ADMINISTRATIVE APPLICATION CHECKLIST Sam SWD #3

APPLICATION FOR AUTHORIZATION TO INJECT

From: Jones, William V., EMNRD
Sent: Tuesday, November 17, 2009 10:52 AM
To: 'Deana Weaver'
Cc: Jerry Sherrell; Reeves, Jacqueta, EMNRD; Ezeanyim, Richard, EMNRD;
'Wesley_Ingram@blm.gov'
Subject: Disposal application from Mack Energy: Sam SWD #3 30-005-29104

WELLBORE SCHEMATIC

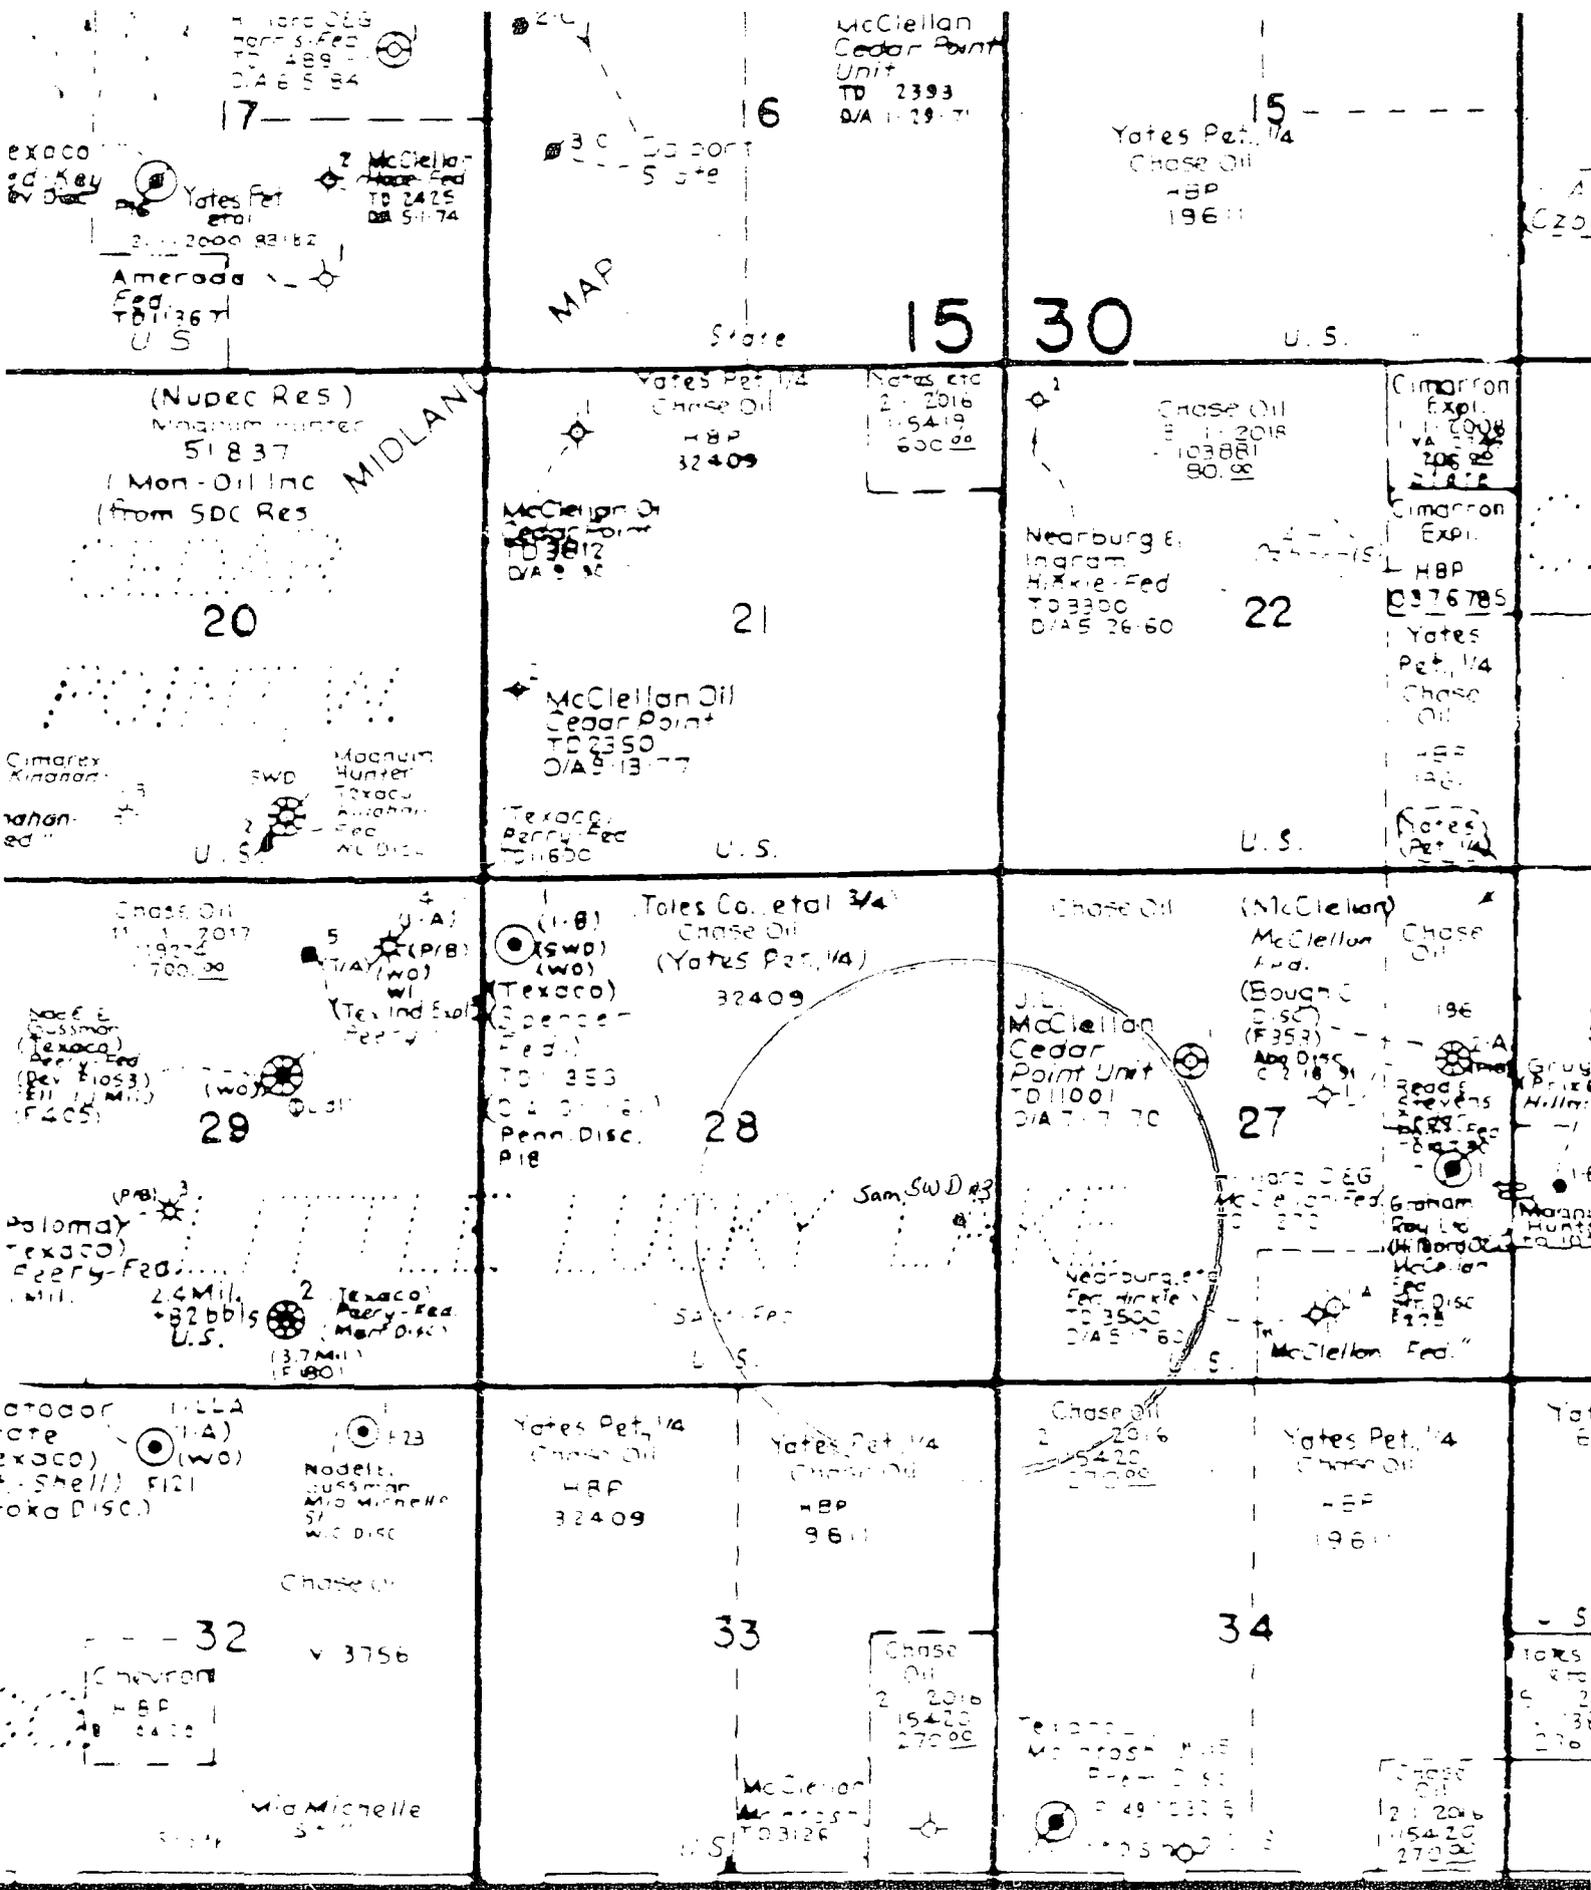
1. What is the well status... Has any work been done? Has the hole been drilled?
2. Isn't there a DV tool planned for the long string – do you know where it will be or where it is?
3. Is this a vertical well? Everything in the well file shows a horizontal well plan.
4. Did the BLM in Roswell or Carlsbad have any comments?
5. What diagnostic logs or mudlogs or dsts will be done from the top of the Devonian to the TD in order to make sure the Devonian and Ellenburger are not productive?
6. What will be the source for the waste water destined for this well? (What Pools? And what companies will use this well for disposal?) The application was not specific.

1. What is the well status... Has any work been done? Has the hole been drilled?
2. Isn't there a DV tool planned for the long string – do you know where it will be or where it is?
3. Is this a vertical well? Everything in the well file shows a horizontal well plan.
4. Did the BLM in Roswell or Carlsbad have any comments?

5. What diagnostic logs or mudlogs or dsts will be done from the top of the Devonian to the TD in order to make sure the Devonian and Ellenburger are not productive?
6. What will be the source for the waste water destined for this well? (What Pools? And what companies will use this well for disposal?) The application was not specific.

1. Currently drilling 11/17/2009 @ 1,576'.
2. Est. DV tool at 8,000'
3. Yes, it is a vertical well.
4. Attach is the Final copy from BLM, showing the change of plan.
5. We will have a mudlogger on the well from 3000' to TD. Also, we will run GR/Neutron Density/Laterlog from the intermediate casing to TD.
6. Abo, Wolfcamp. All Mack Energy water.
